Access Compliance Report

Public Rights-of-Way

(Curb Ramps)

Intersection ID: 10020495	Main Street: BARCLAY_DOWNS_DR	Cross Street: N/A	Location: NW
ADA ID: 8F496AF91E4B	Ramp Type: Perpendicular	Initial Pass/Fail: Fail	Overall Compliance: No
		Severity Score: 35

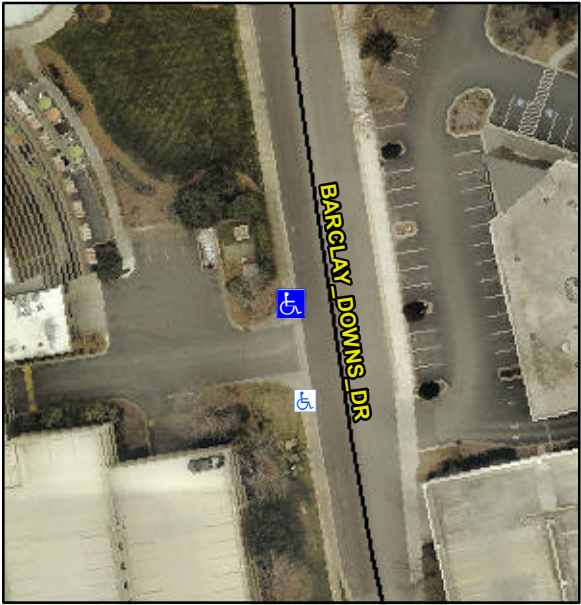
Codes/Mitigation Info/Possible Solution			Field Measurements/Component Compliance		
	Possible Solutions:		Compliance	Description	Data
	Remove & Replace Entire Ramp.		No	Ramp Length (in)	38.0
			No	Ramp Width (in)	42.0
			N/A	Flare Type LT	N/A
			N/A	Flare Slope LT (%)	N/A
			N/A	Flare Traversable LT?	N/A
			N/A	Landing Length (in)	N/A
			N/A	Landing Width (in)	N/A
			N/A	Landing Slope (%)	N/A
			N/A	Landing X Slope (%)	N/A
<p>Surveyor Notes:</p> <p>N/A</p> <p>PROW/ADA:</p> <p>Not Found, R304.5.1, R304.2.2, R304.5.3</p>			N/A	Landing Curb? (Y/N)	N/A
			N/A	Shared Landing?	N/A
			N/A	Gutter Ponding?	N/A
			N/A	Gutter Lip Ht (in)	N/A
			No	Painted X Walk1?	N/A
				X Walk 1 Direction	To S
			N/A	X Walk 1 Width (in)	N/A
				X Walk 1 Slope (%)	2.4
				X Walk 1 X Slope (%)	0.7
			N/A	Ramp inside XWalk1?	N/A
<p>Street 1 Name</p> <p>Stop Condition-Street 2</p> <p>Street 2 Name</p> <p>Stop Condition-Street 1</p>			N/A	Road Slope (%)	N/A

N/A	Road X Slope (%)	N/A
			N/A	Any Obstructions?	N/A
				Obstruction Type	
			N/A		
			N/A		
			N/A		
			N/A		
			N/A		
			N/A		
<p>Total Cost:</p> <p>\$ 1850.00</p>			N/A		
			N/A		
			Yes	Surface Condition? (G/P)	Good
